ADA Curb Ramp New Construction Inspection Form (Perpendicular)

NW 293rd

23885.56

NW King

PERPENDICULAR RAMP (PR)

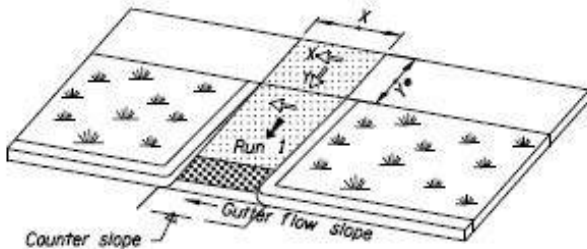
Cross Slope 1

2.2

☒

Slope X

3.0

☒

Tool joint in middle of TS
